ADDENDUM NO. 3

DATED: November 14, 2024

PROJECT:	WSD New Sr. High School	**DATE:**	11/14/2024
OWNER:	Wynne School District	**PROJECT NO:**	A-23010
TO:	Gary Hoyt Nabholz Construction	**CONTRACT FOR**:	General Construction

1 FIRST FLOOR PLAN : AREA B - NOTE
1/8" = 1'-0"

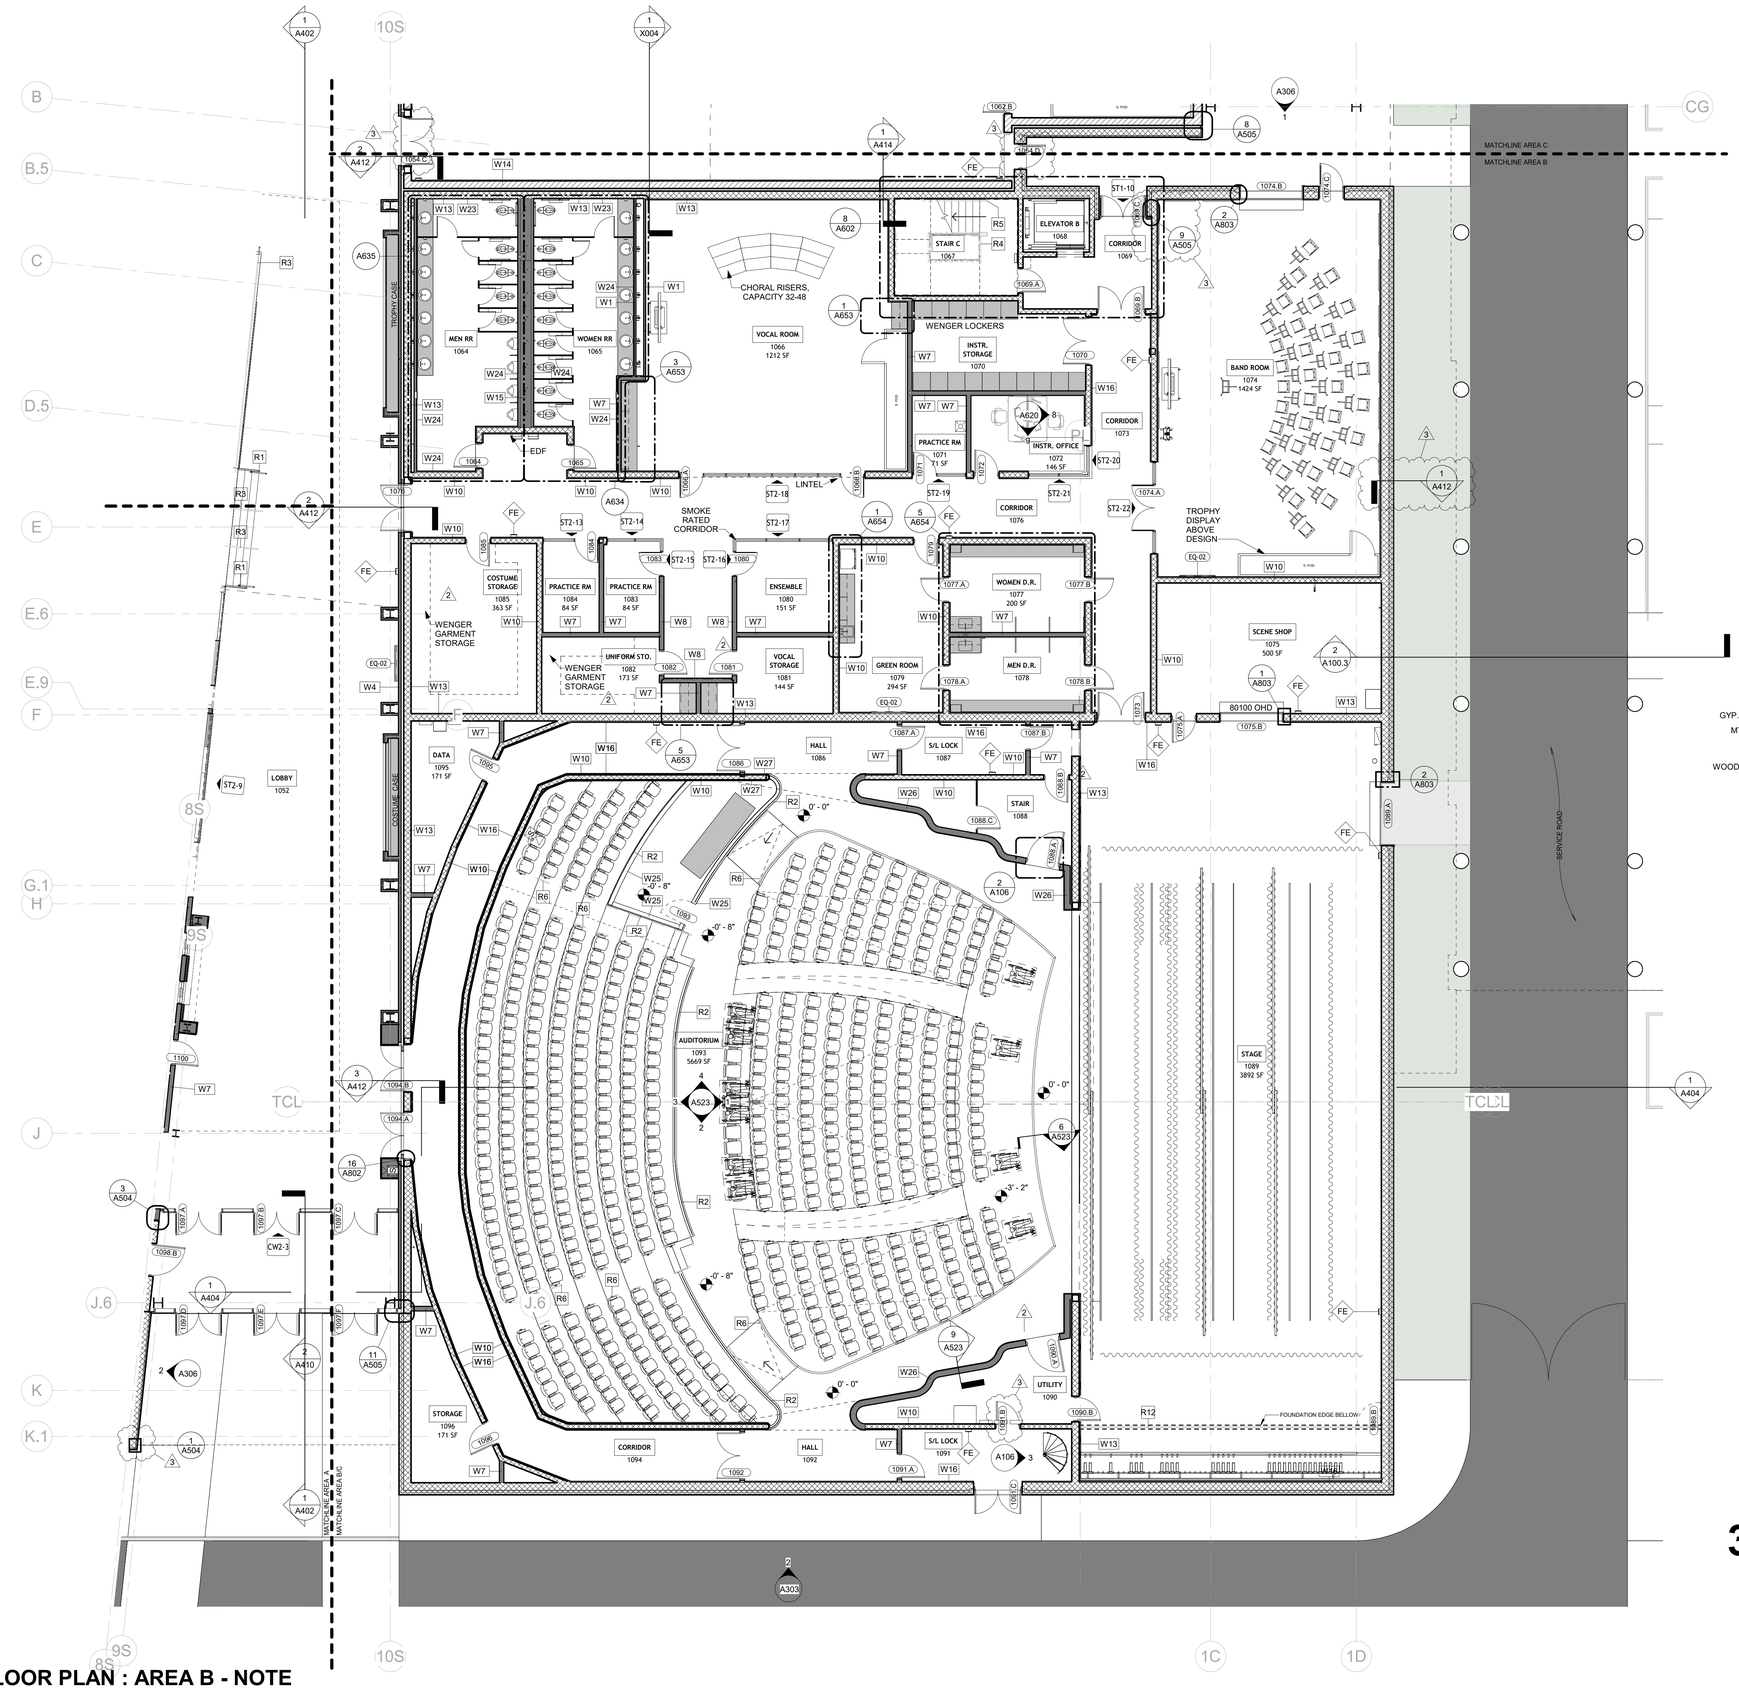
36. Sheet A106 FIRST FLOOR AREA B -NOTE PLAN: See clouded revision ADD. 3
37. Sheet A108 FIRST FLOOR AREA C -NOTE PLAN: See clouded revision ADD. 3
38. Sheet A109 FIRST FLOOR AREA C -DIMENSION PLAN: See clouded revision ADD. 3

A114

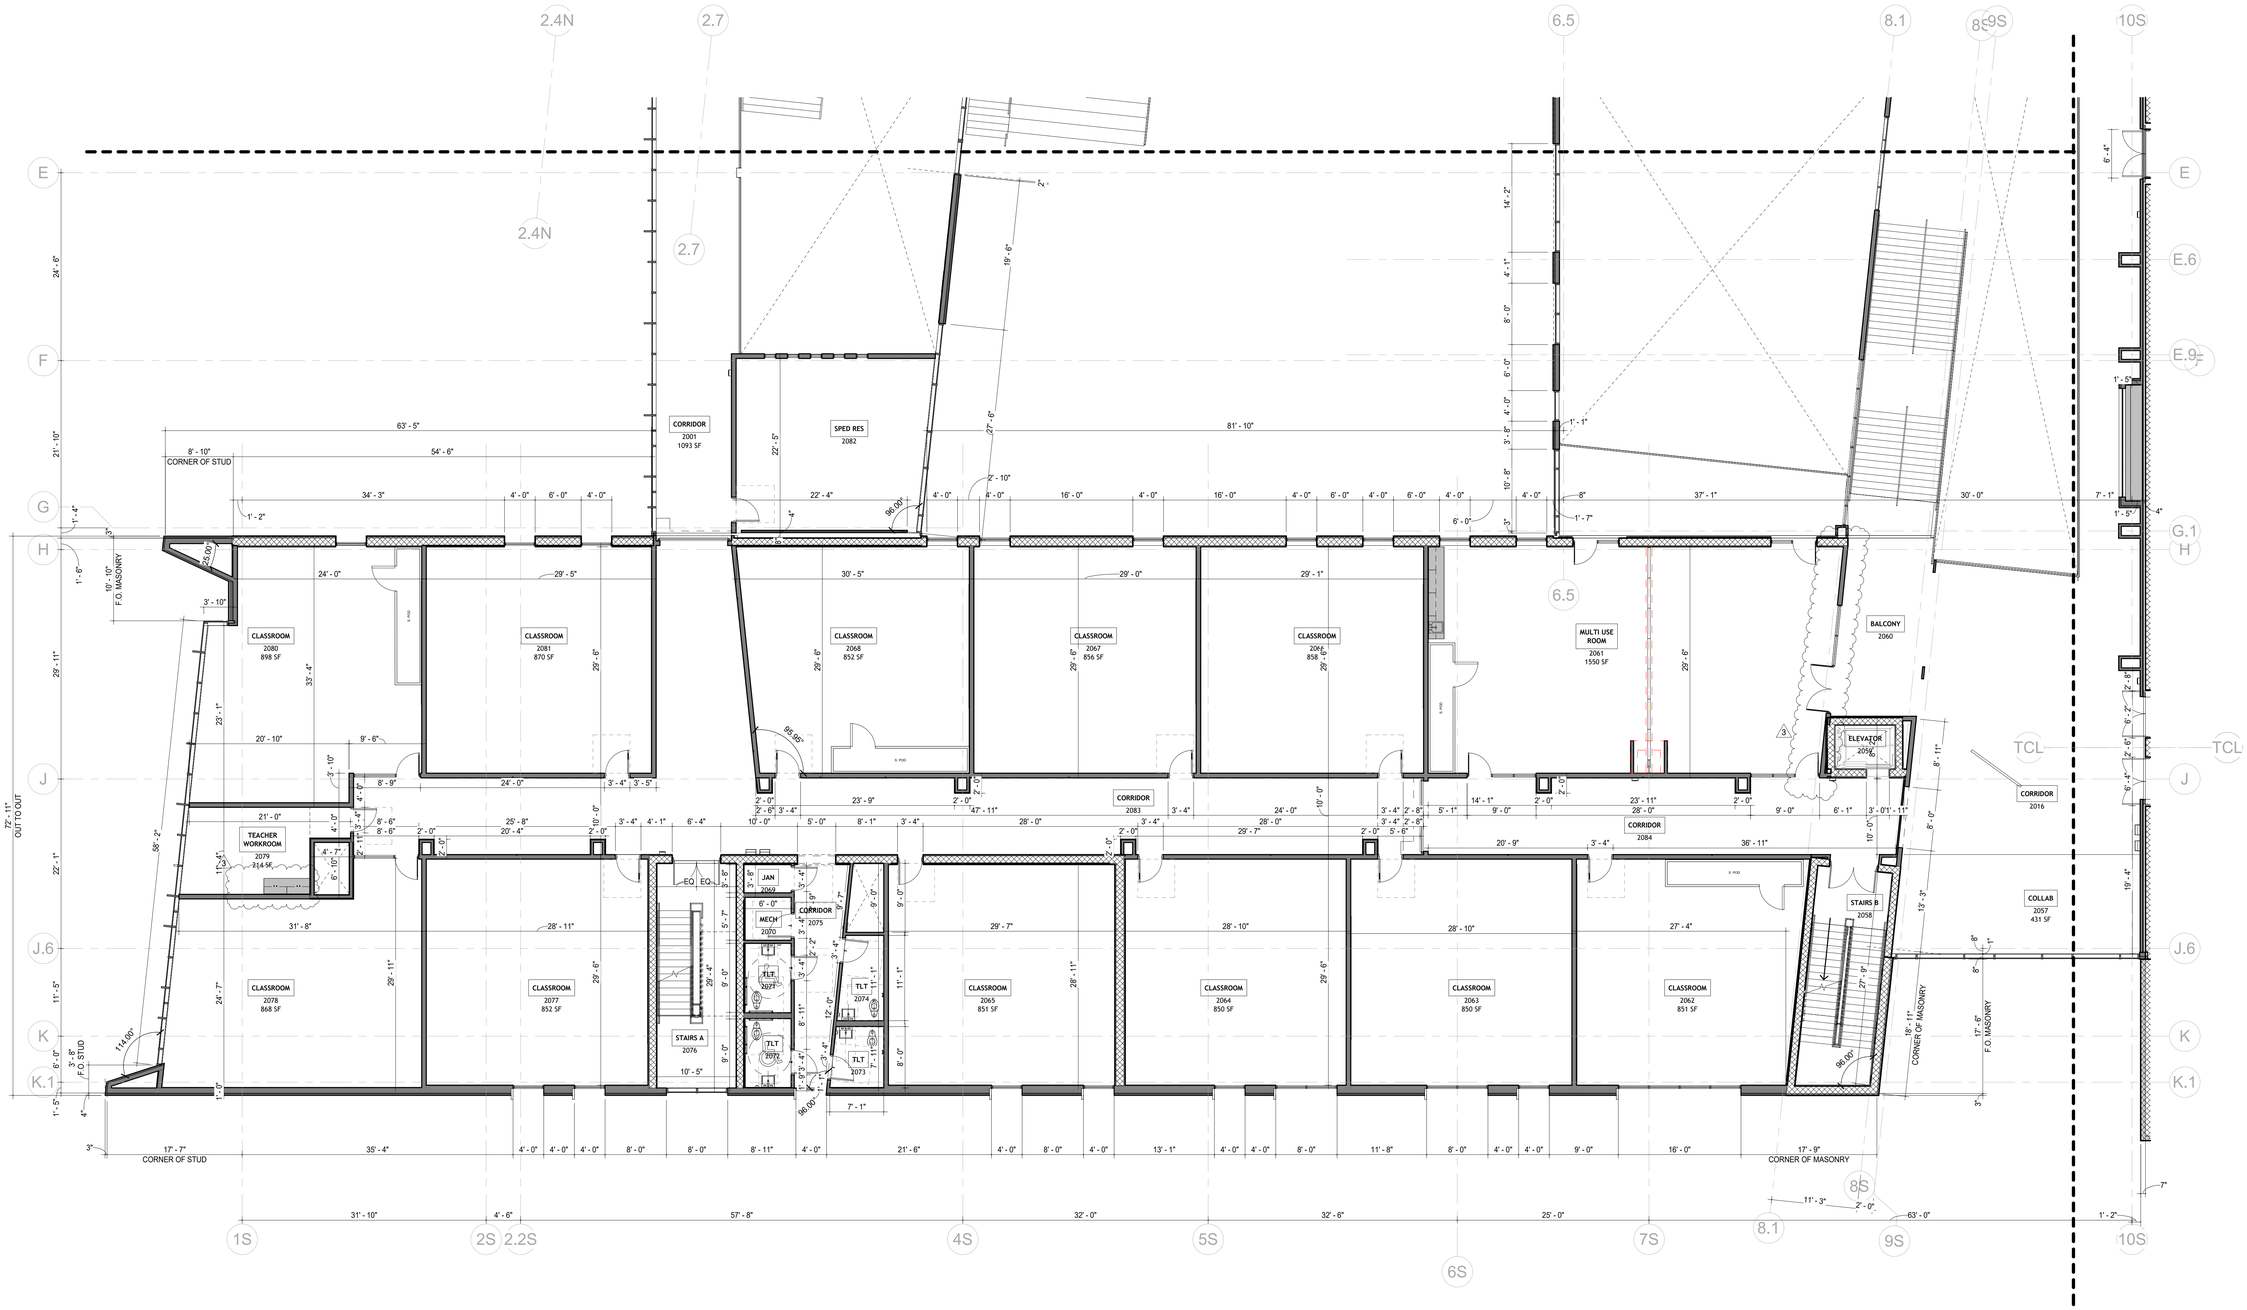
42. Sheet A114 SECOND FLOOR AREA A SOUTH -DIMENSION PLAN: See clouded revision ADD. 3
43. Sheet A115 SECOND FLOOR AREA B -NOTE PLAN: See clouded revision ADD. 3

28	Need retractable wall details in A114(Classroom Partition)	Nabholz	Addendum No. 3
29	Need countertops selection in a finish schedule (Bathroom counters in multiple locations, counter at box office, counter in press box, etc.)	Nabholz	Countertop selections added to plans
30	Need Spec for Laboratory Equipment 11-5300/ 11-4000 Food Service Equipment/ 11-4XXX Facs Lab Equipment	Nabholz	Addendum No. 3
32	Spec 12-6100 Fixed Auditorium Seating & Spec 12-6200 Portable Audience Seating-Are both labeled NOT FOR CONSTRUCTION	Nabholz	Addendum No. 3
38	Need elevations & additional details for the folllowing wall coverings: Marker Wall Coverings(MWC1), Tackable Wall covering (TWC1), Specialty Wall Covering(SWC), Writing Wall(PGA904), Teaching Wall (A901)Rm1109)	Nabholz	Writing wall and teaching wall have been removed. Details for other items have been added to plans in addendum #2
41	Need "WP" Wallfinish detail rm1140 a901, Not on legend	Nabholz	"WP" wall finish removed from plans in addendum #2

1 THIRD FLOOR PLAN - OVERALL

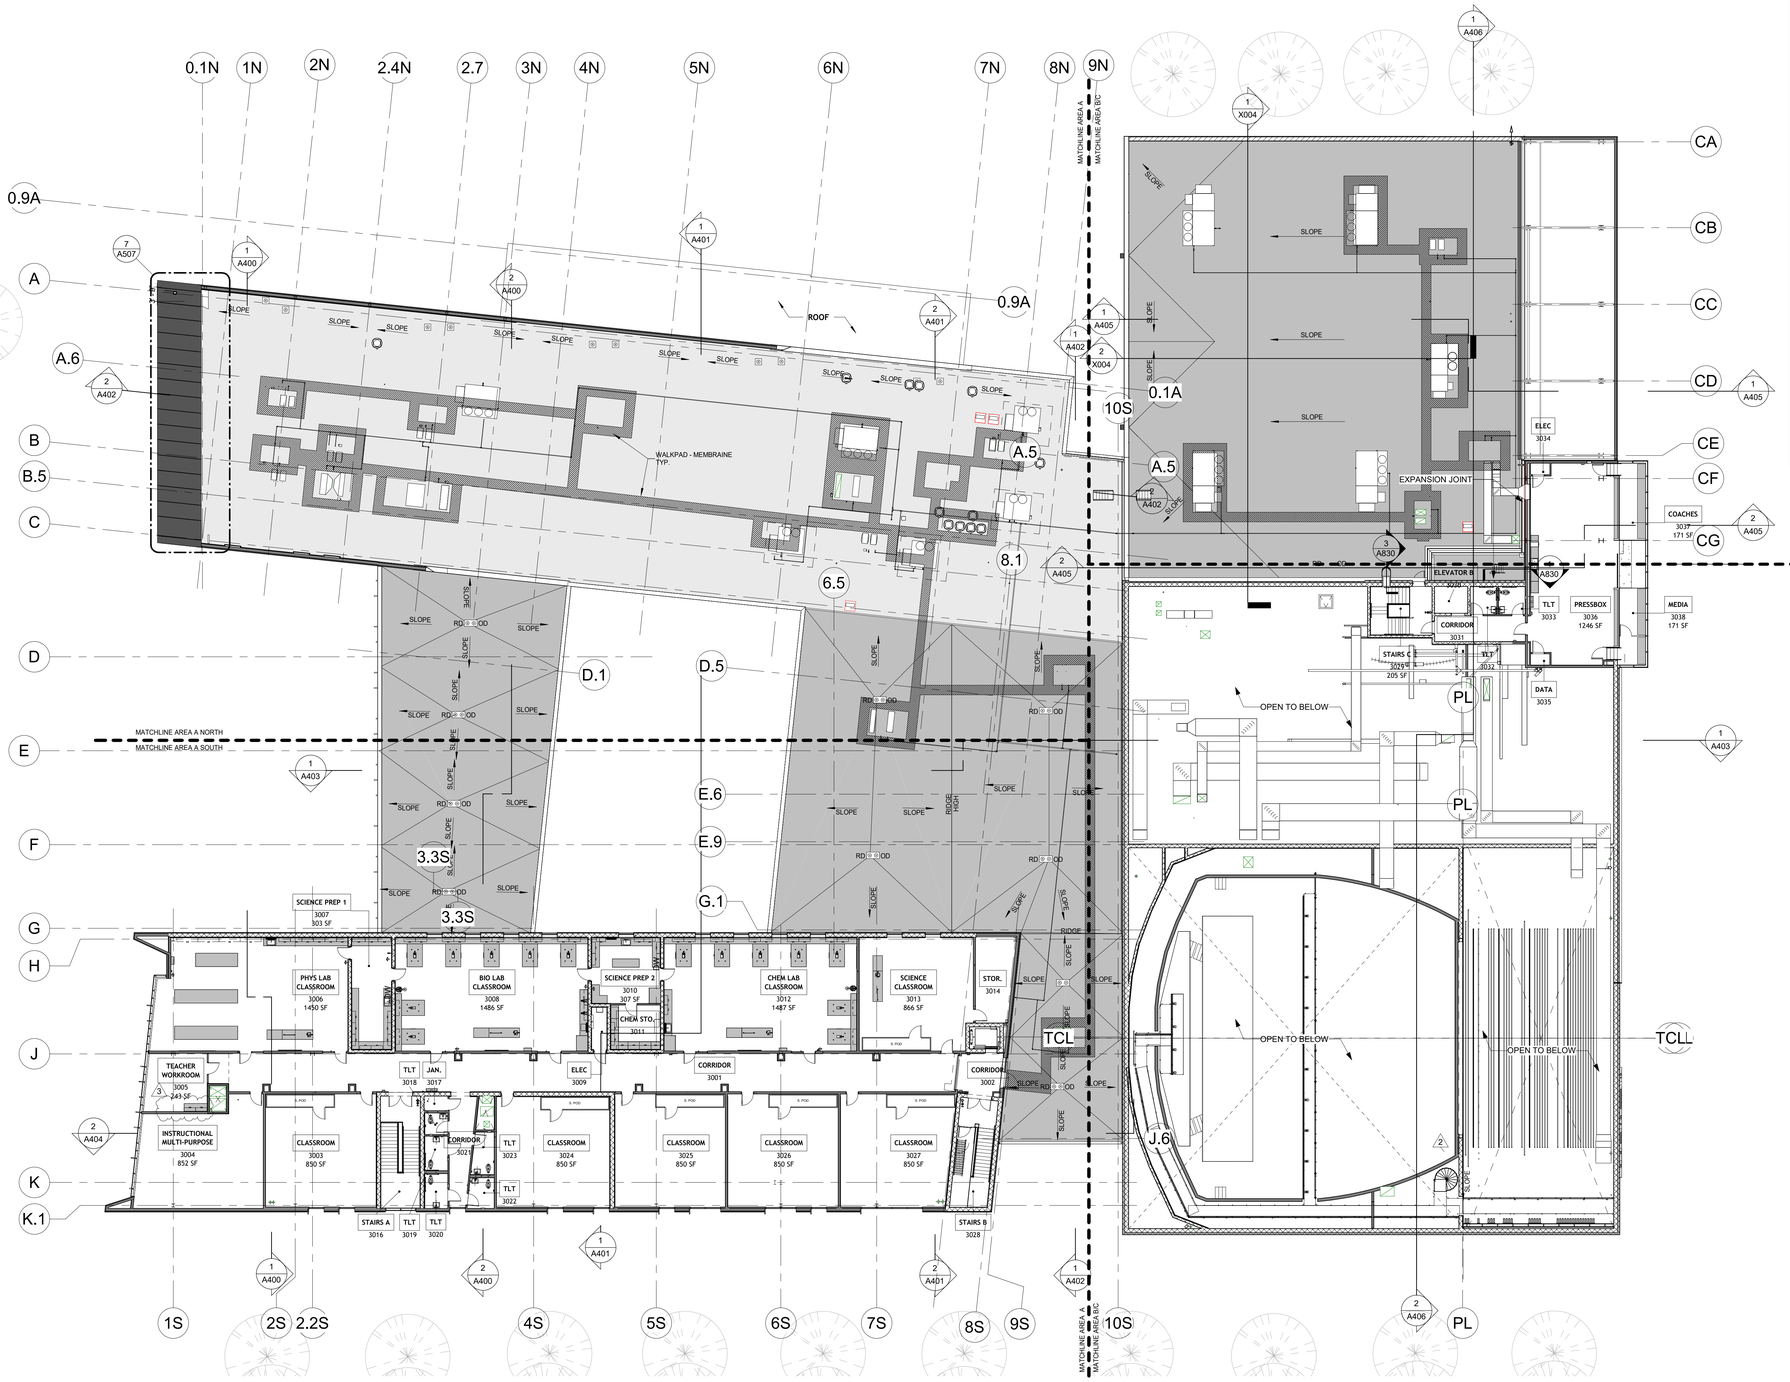
44. Sheet A119 THIRD FLOOR PLAN -OVERALL: See clouded revision ADD. 3
45. Sheet A120 THIRD FLOOR AREA A SOUTH -NOTE PLAN: See clouded revision ADD. 3
46. Sheet A121 THIRD FLOOR AREA A SOUTH -DIMENSION PLAN: See clouded revision ADD. 3
